**SOUTHERN CALIFORNIA EDISON'S  
SAN JOAQUIN CROSS VALLEY LOOP  
220 KV TRANSMISSION LINE PROJECT**

**CPUC A.08-05-039**

Final Environmental Impact Report  
(Response to Comments)

Prepared for:  
California Public Utilities Commission

**Figure 4.6(RTC)-2**  
Seville Subdivision Lines and Hamlet Development Boundary

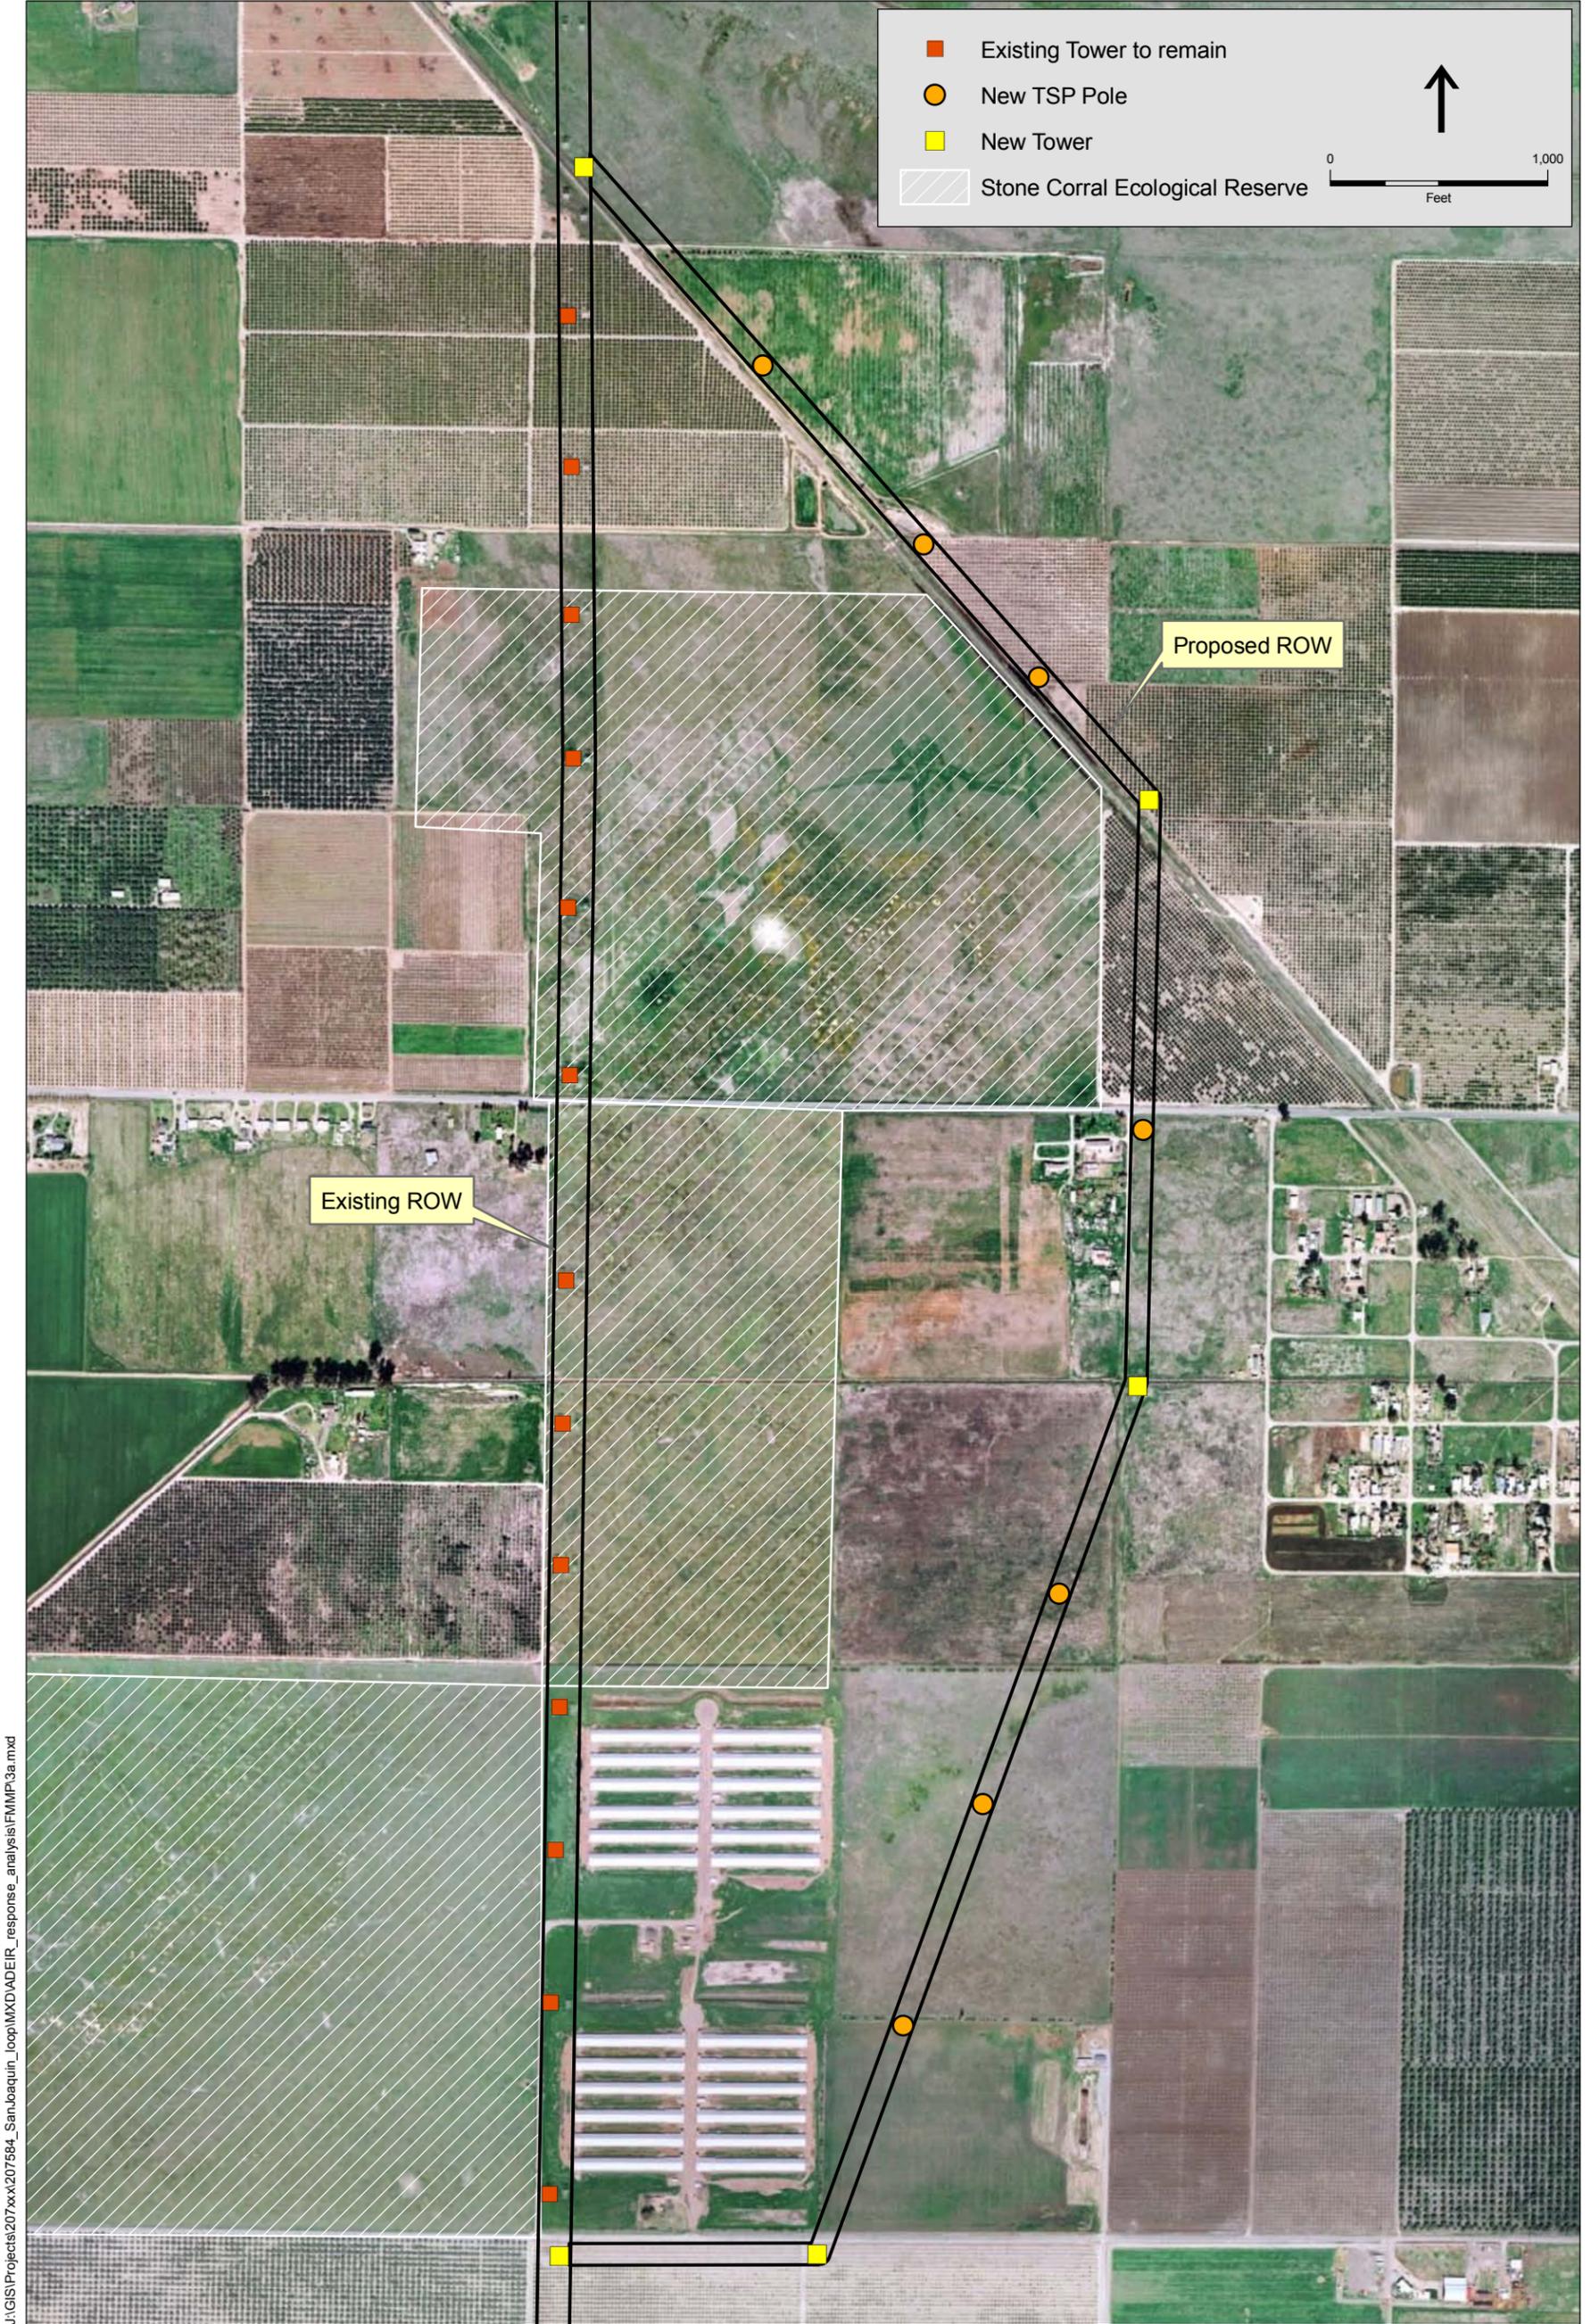
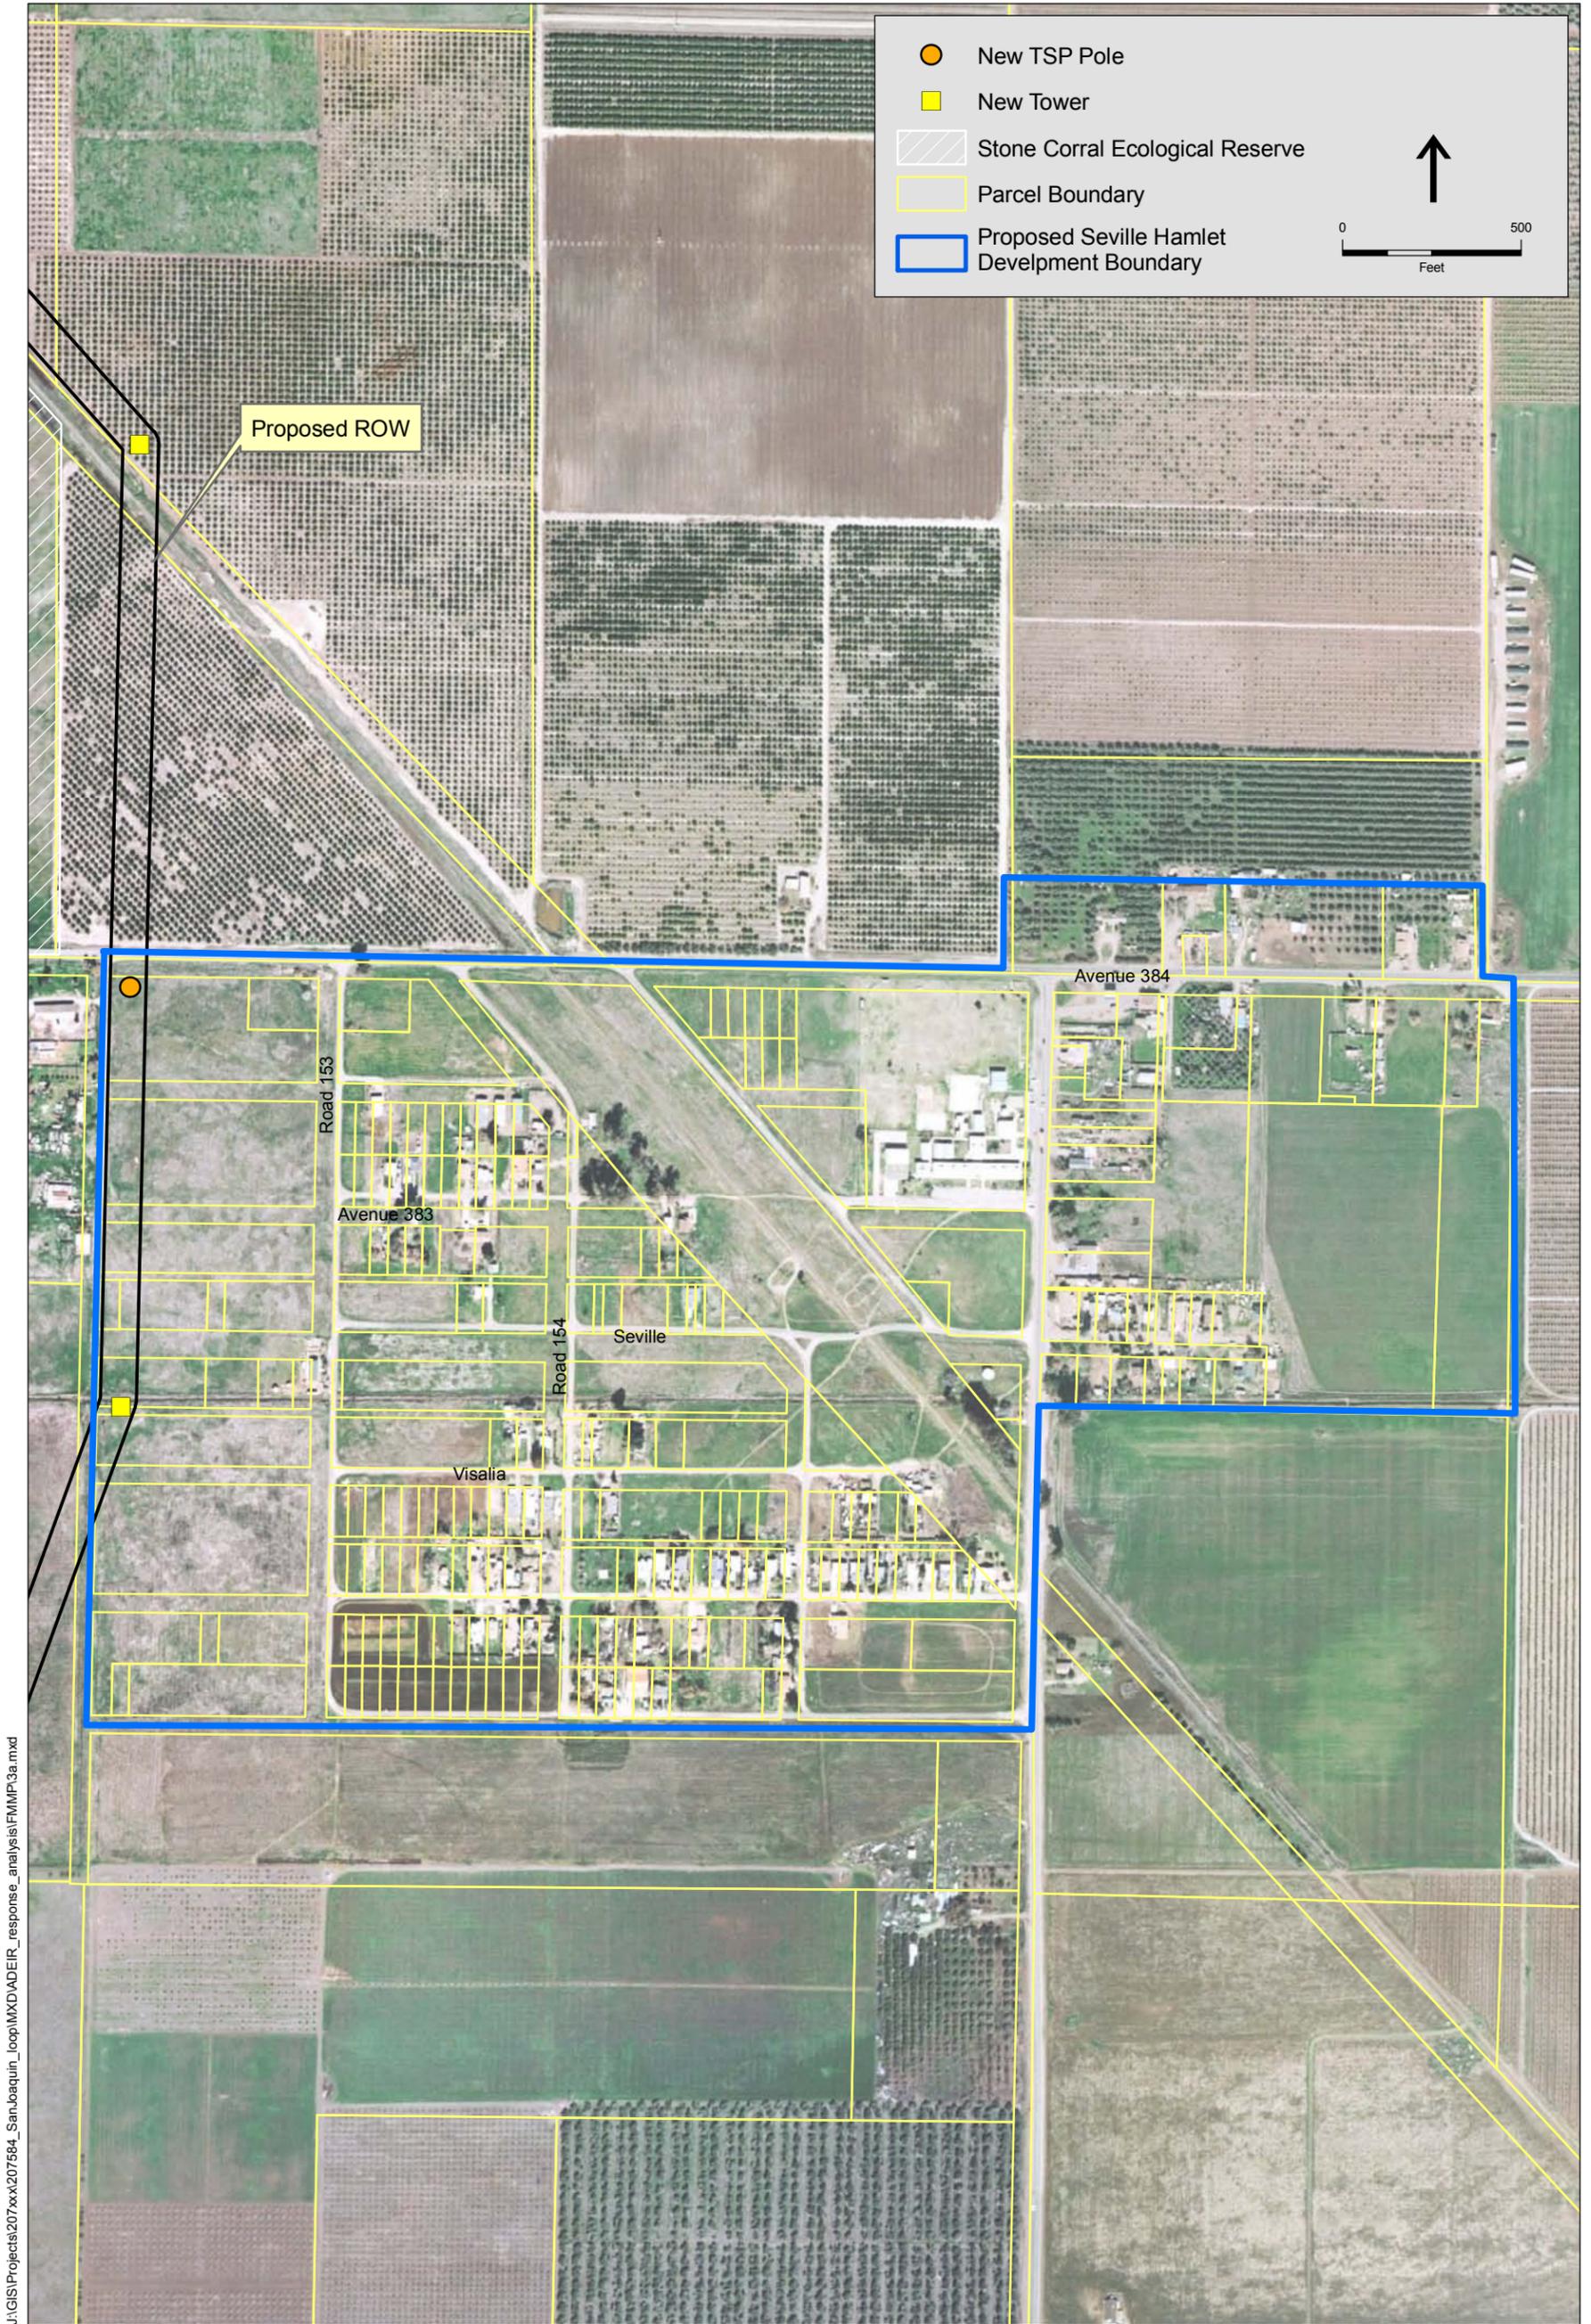
Another potentially adverse land use issue arises where the Alternative 3A alignment would cross previously subdivided parcels along the western portion of Seville. Seville is identified in the current Tulare County General Plan as a “rural development center” and in the proposed Draft 2008 General Plan as a “hamlet.” In the Draft General Plan, new Policy PF-3.1 would establish Hamlet Development Boundaries, within which urban development for the hamlet would need to occur. Figure 4.6(RTC)-2 is a portion of the Alternative 3A alignment near Seville showing the existing subdivision lines and the Seville Hamlet Development Boundary as depicted in the Draft General Plan. Construction of Alternative 3A would likely result in a loss of use for at least eight parcels within the draft Hamlet Development Boundary.

With regard to aesthetic impacts, Alternative 3A would result in approximately 2.4 miles of new 220 kV double circuit transmission line (including associated towers and poles) in a 100-foot ROW where none currently exists. There are four private residences that would be in close proximity along this 2.4-mile segment of new line. The first residence can be seen near the bottom of Figure 4.6(RTC)-1 just east of where Alternative 3A turns to the northeast. Slightly further north, there is a cluster of three residences and other private structures right at the edge of the Alternative 3A ROW just west of Seville. These residences are shown more clearly in Figure 4.6(RTC)-2. A number of other residences in the southern and western portions of Seville would also have views of the new transmission line from a distance of as little as 600 feet. In

addition, one business (a turkey farm, visible in the lower left of Figure 4.6(RTC)-1) would have the new transmission line immediately adjacent to its southern and eastern boundaries. Together with the existing Big Creek – Rector transmission lines on its western boundary, this business would become surrounded on three sides by transmission lines and structures.

Alternative 3A (as modified here to be legally feasible by avoiding the railroad ROW) passes screening with regard to meeting the basic project objectives, meeting the tests of feasibility, and lessening significant effects of the Proposed Project (namely, impacts to Farmland). However, as described above, there are a number of adverse issues associated with Alternative 3A that must be considered. At this level of analysis, it is neither possible nor necessary to quantify with absolute certainty the adverse impacts identified for Alternative 3A. However, it is possible to provide a meaningful evaluation, analysis, and comparison to the Proposed Project and the other alternatives.

**Figure 4.9-4**  
City of Farmersville General Plan Land Uses

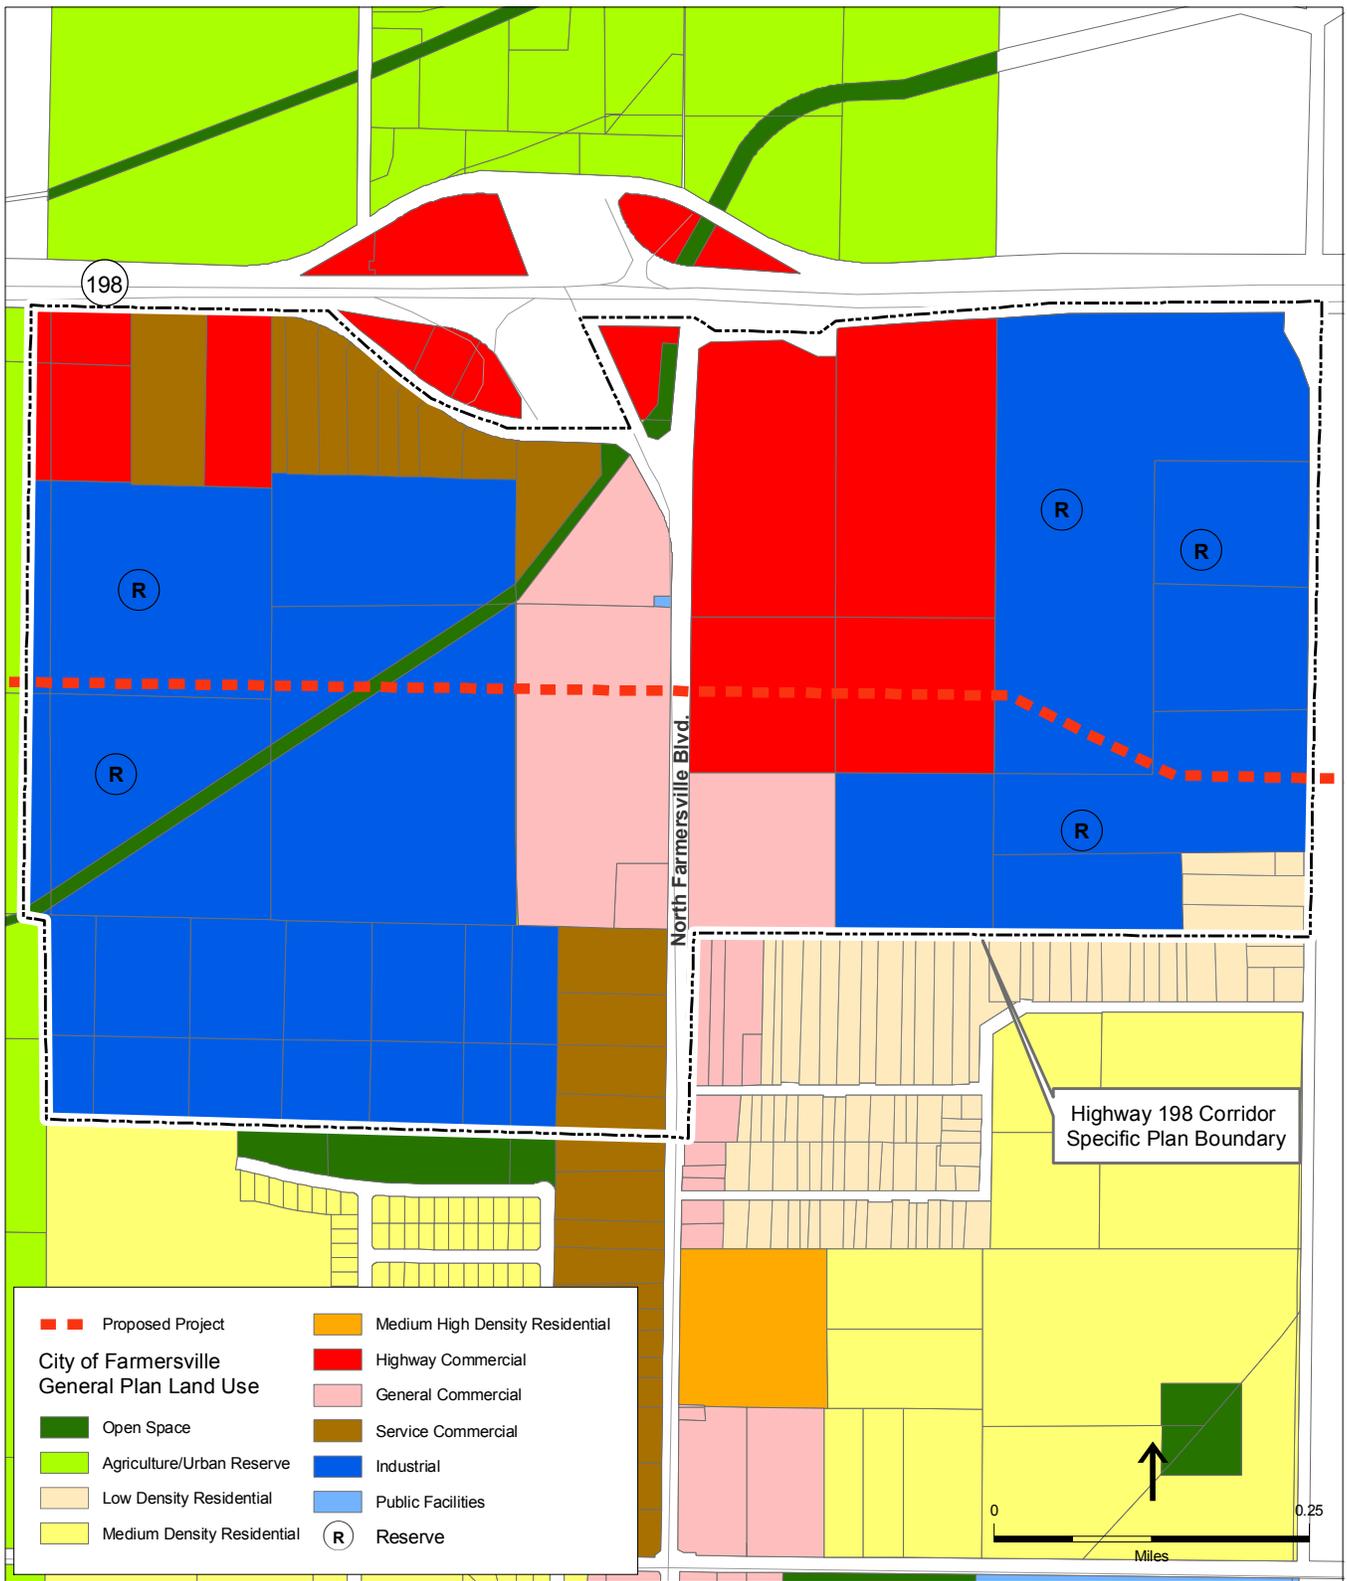
Response O10-13 The commenter requests a visual diagram depicting the Proposed Project alignment within the City of Farmersville's General Plan Land Use and Zoning diagrams. The Draft EIR, page 4.9-11, Figure 4.9-4, is a map showing the City of Farmersville General Plan Land Uses at the time of the NOP's publication in August 2008. Subsequent to amendments made to the City of Farmersville General Plan and Highway 198 Corridor Specific plan land use designations,

and zoning designations, were adopted as of May 2009. Figure 4.9-4 has been updated to include the most recent land use designations (see Response I11-1). A diagram, or map, depicting the Proposed Project's alignment in relation to zoning designations would show the Proposed Project as traversing parcels zoned *Industrial*, *General Commercial*, and *Highway Commercial*. See Response I11-1 for text changes made to Section 4.9, *Land Use, Planning, and Policies*, in response to these subsequent amendments.

In addition, Figure 4.9-4 has been updated to reflect the changes in land use and zoning designations, and is attached in this Response (see below).
